Re: Stowe Parking Lot Improvements – Parking Lot A1, A2, A3 Expansion  
Site Plan Revisions

On behalf of VR US Holdings II, LLC, please find enclosed a revised set of the Stowe Mountain Parking Lot Improvements – A Lots Plans. As a follow-up to the 11/7/2023 DRB hearing, the plans have been revised to address feedback received both from Staff and the Board. These revisions include:

## Stowe Mountain Parking Lot Improvements - A Lots

# Overall Site Plan

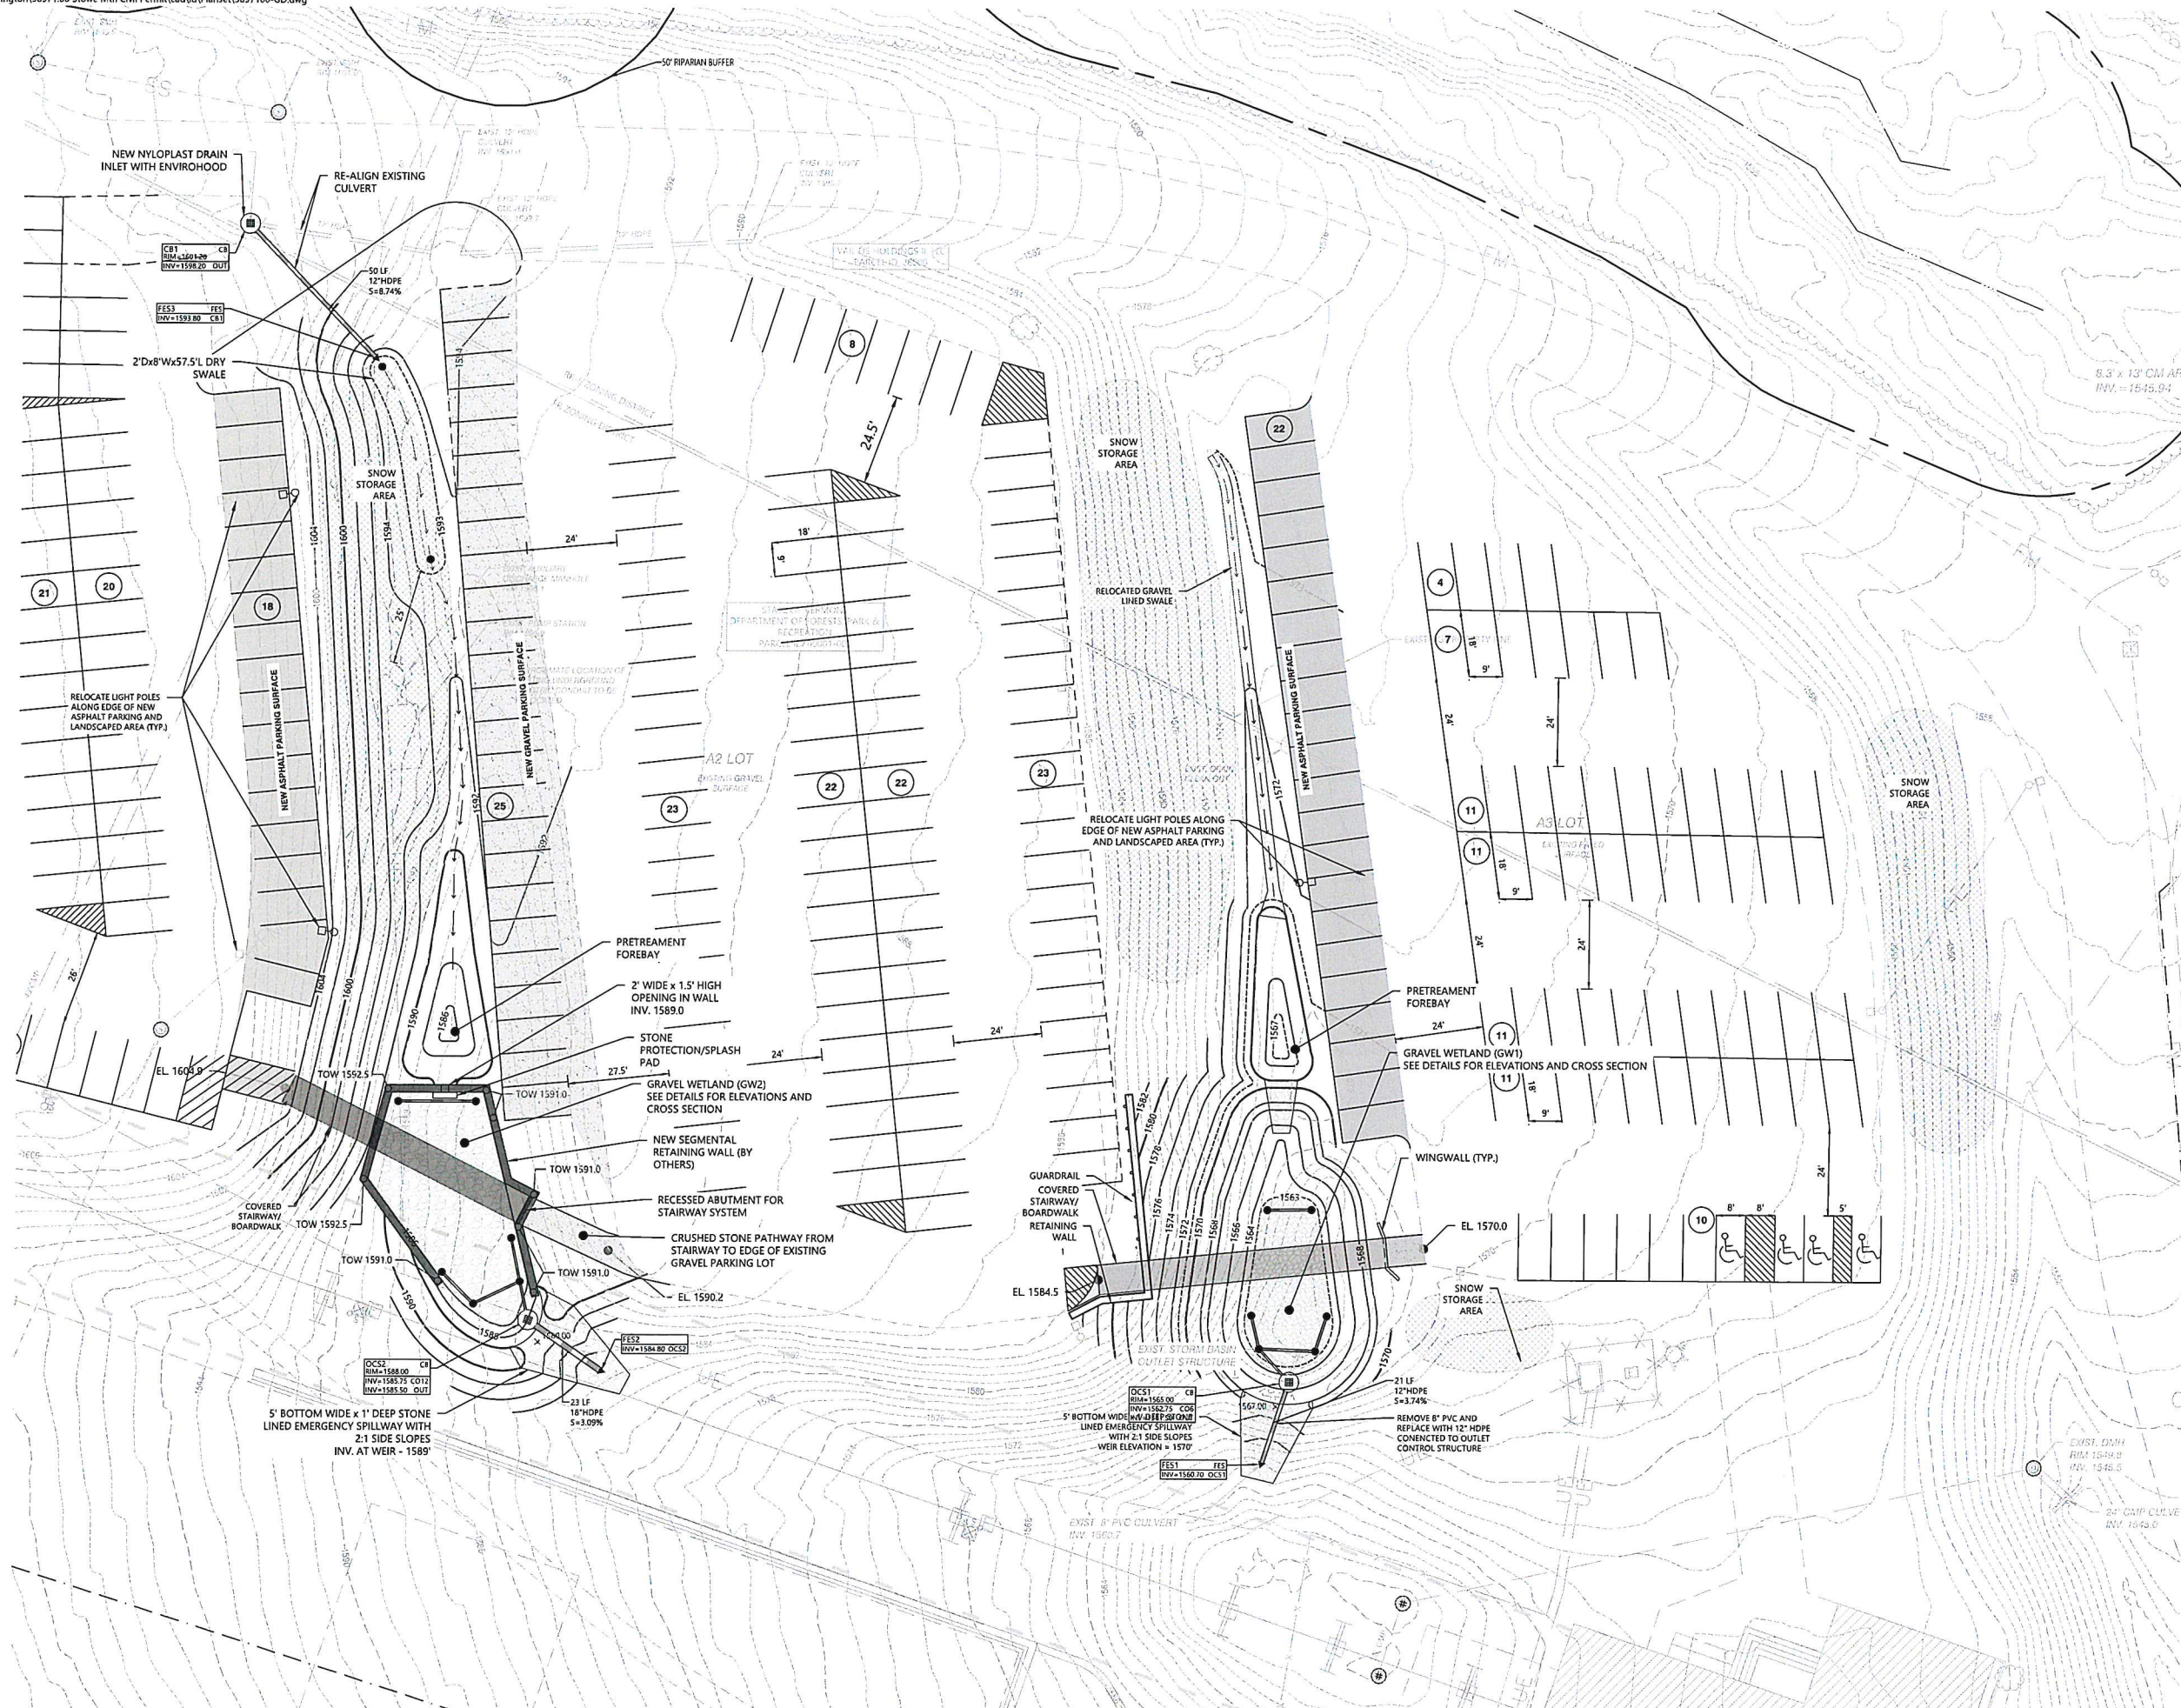
In reviewing the zoning regulations, commercial ski infrastructure is a conditional use within the FR Zoning District. A portion of the existing parking lot is currently located with the FR Zoning District and the proposed expansion will not have an undue adverse effect on the character of this district as the parking expansion is continuous to the existing parking lot, has been designed to avoid wildlife habitat, natural and scenic resources, and will help provide infrastructure to support outdoor recreation at the ski resort. The SKI-PUD boundary has been labeled on Sheet C2.00.

- 2) Updated Drive Aisle and Parking Lot Striping – The attached plans have been revised to provide a minimum two-way drive aisle width of 24' per Table 15.1 of the Zoning Regulations. Please see Sheet C2.00 for updated parking stall and drive aisle dimensions / layout.

In addition to the parking affidavit, the revised plan set depicts updated parking counts for the Control Lot, A1, A2, A3 on Sheet C2.00. The parking counts have been updated to reflect the revised parking lot striping and inclusion of landscape peninsulas. The existing lots have a total of 337 parking spaces. The proposal will add 77 spaces, increasing the total number of parking spaces to 414. Please see Sheet C2.00 for additional information.
